SLIDE-OUTS

The pressure angle (PA) on all Lippert Through Frame slide-out gear packs has changed from 14.5PA to 20PA. This will require a change in replacement parts used for through frame slide-outs. See TI 001 to determine the gear rack and spur gear currently in use.

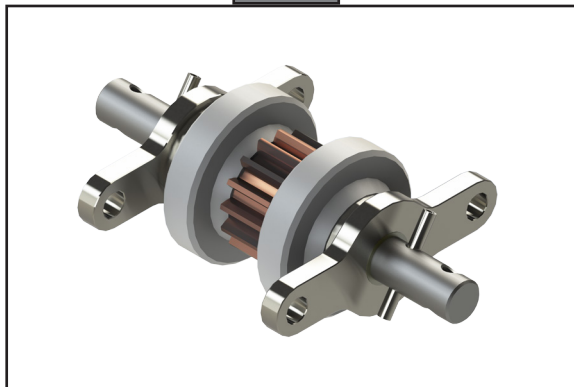
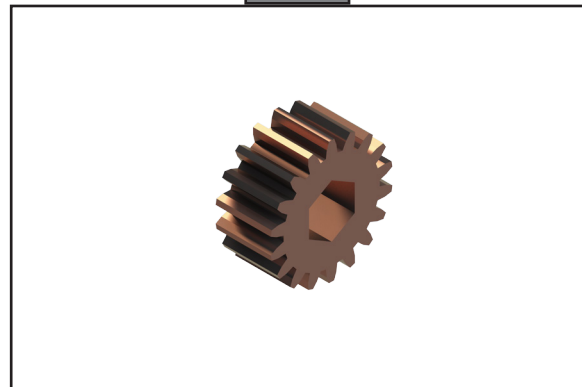
For customers with broken teeth in a gear pack, replacement parts will be a new gear pack (20PA) and an original spur gear (14.5PA). The pressure angle of the spur gear on the new gear pack will not mesh with the pressure angle of the old gear rack. The new gear pack will need to be disassembled, and the spur gear on the new gear pack will need to be replaced with the spur gear **122739**.

- 2" x 2" Gear Pack Assembly (20PA) - [281331](#) (Fig. 1)
- 2 ½" x 2 ½" Gear Pack Assembly (20PA) - [324869](#) (Fig. 2)
- 2 ½" x 2 ½" Heavy Duty Steel Gear Pack Assembly (20PA) - [123356](#) (Fig. 3)
- Spur gear (14.5PA) - **122739** (Fig. 4)

1. Remove the roll pin (if equipped).
2. Remove the mounting plate.
3. Remove the spur gear.
4. Replace the spur gear with spur gear **122739**.
5. Reverse the process.

Fig. 5.2

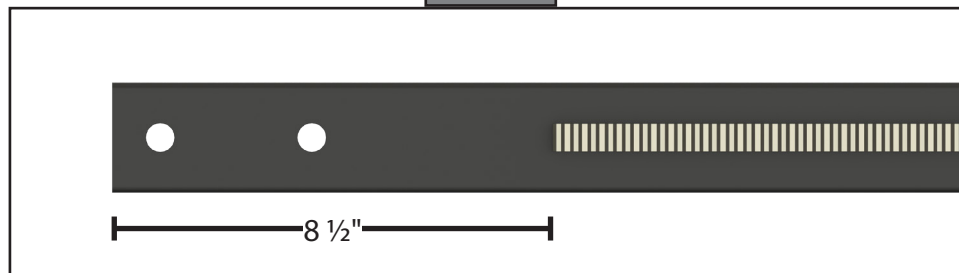
For customers with broken teeth in a gear rack, replacement parts will be two new inner arms, and two new gear packs. Both inner arms and gear packs must be replaced at the same time in order to maintain timing. The pressure angle of the spur gear on the new gear pack will not mesh with the pressure angle of the old gear rack.

- 2" x 2" Inboard (20PA) - **163778** (Fig. 5.1, Fig 5.2)
- 2" x 2" Outboard (20PA) - **145736** (Fig. 6.1, Fig 6.2)
- 2" x 2" Gear Pack Assembly (20PA) - **281331** (Fig. 1)
- 2 ½" x 2 ½" Inboard (20PA) - **143710** (Fig. 7.1, Fig 7.2)
- 2 ½" x 2 ½" Outboard (20PA) - **143707** (Fig. 8.1, Fig 8.2)
- 2 ½" x 2 ½" Gear Pack Assembly (20PA) - **324869** (Fig. 2)
- 2 ½" x 2 ½" Heavy Duty Steel Gear Pack Assembly (20PA) - **123356** (Fig. 3)
